Work Order ID 134869

Item Name: Quick Release Basket and Long Cargo Tube Mounting Provisions, Fits LH or RH

DART SERVICE INSTRUCTION

TO AMEND INSTALLATION INSTRUCTIONS D350-607-3 Rev.D,
INSTALLATION INSTRUCTIONS D350-607-4 Rev. C AND
INSTRUCTIONS FOR CONTINUED AIRWORTHINESS ICA-D350-607 REV. 6
REF TCCA STC: SH94-14
REF FAA STC: SR00213NY
REF EASA STC: EASA.10016996
REF BRAZILIAN STC: 2007S03-03/-04/-05/-06

FIGURE 1: INSTALLATION OF D4775-041 FWD STRUT

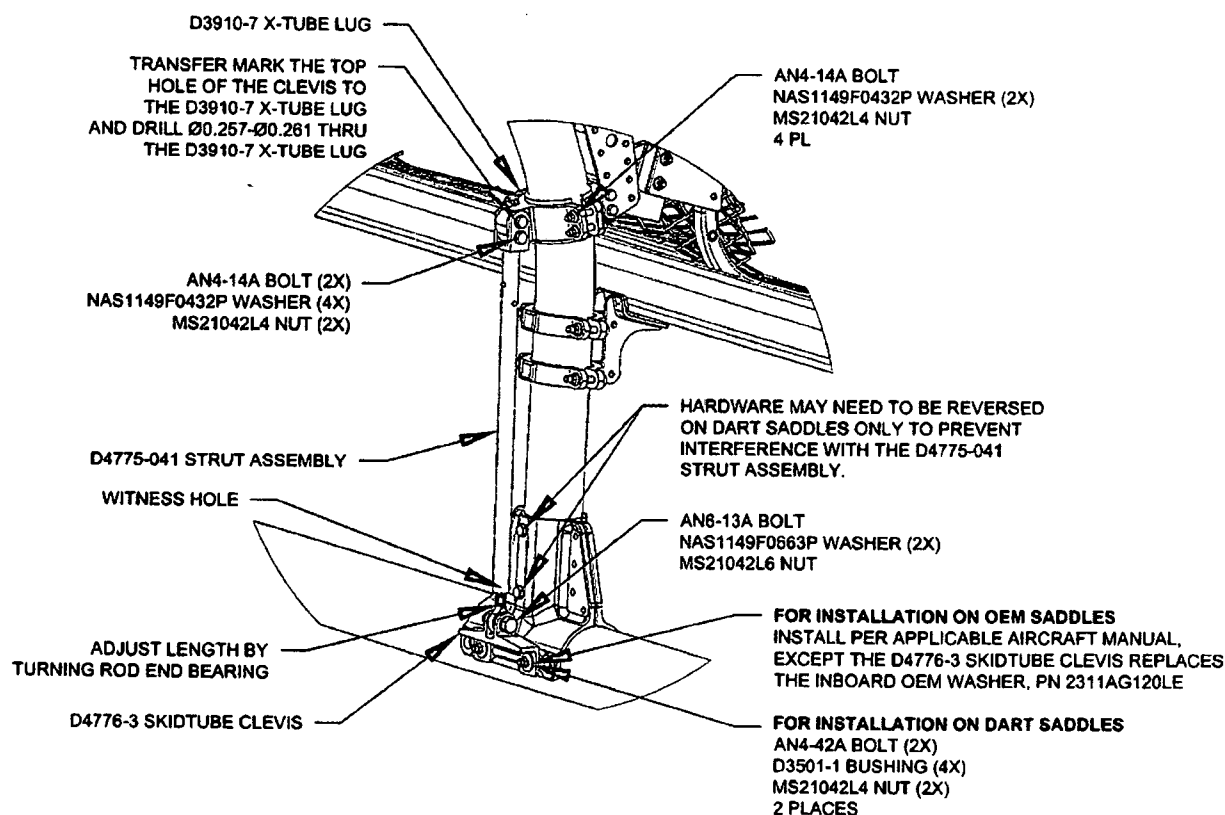
- 3.1 Substitute the Forward Lower D3910-5 X-Tube Lug with the D3910-7 X-Tube Lug as shown in Figure 1.
- 3.2 Install the forward D4775-041 Strut Assembly. Transfer mark from the upper hole on the clevis of the D4775-041 Strut Assembly to the D3910-7 X-tube Lug and drill thru the lug $\varnothing 0.257 - \varnothing 0.261$ as shown in Figure 1. Touch up chemical conversion coating per MIL-DTL-5541. Check the witness holes located at the bottom end of the D4775-041 Strut Assemblies to ensure that the thread from the rod end extends past the witness hole.
Torque MS21042L4/-4 nuts to 50-70 in-lbs (5.7-7.9 N-m). Torque MS21042L6/-6 nuts to 160-190 in-lbs (18.1-21.5 N-m).
- 3.3 Complete the installation in accordance with Installation Instructions D350-607-3 Rev. D or D350-607-4 Rev. C.
